ADDENDUM NO. 1

January 5, 2023

The Bidding Documents for
Design/Build Proposals
City of Erlanger
Public Works Facility

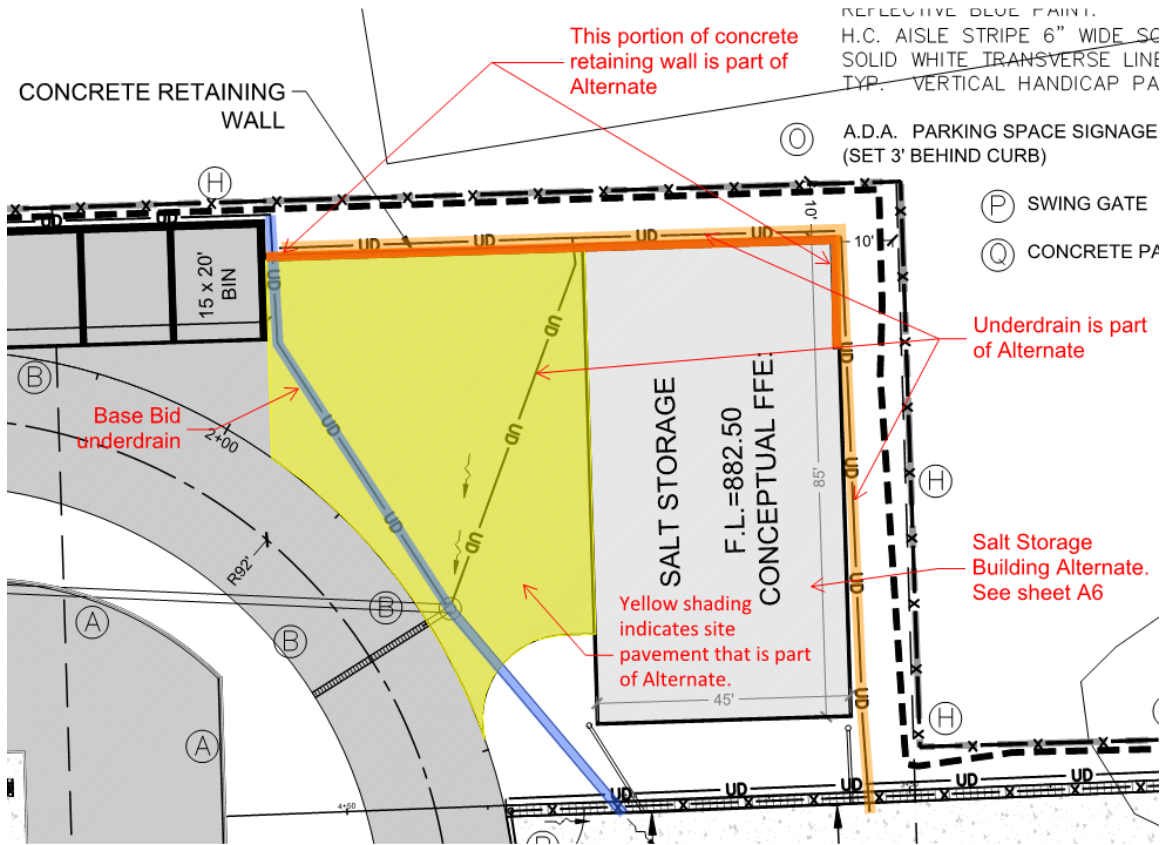
1. All work associated with the Salt Storage Building shall be an ADD Alternate and shall be included as a separate cost on the Bid Form reissued with this Addendum.

Refer to the Image on the next page from Sheet 4 of the Civil drawings: The Alternate shall also include the concrete retaining wall extending southeast from the 15x20' material bins up to (and incorporated into) the salt storage building, the underdrain associated with said wall, and site pavement between the salt storage building and the material bins and grading as indicated in Sheet 5 in this same area.

Base Bid grading in this area shall be as required to blend from existing property line grades to base bid installed material storage bins and pavement.
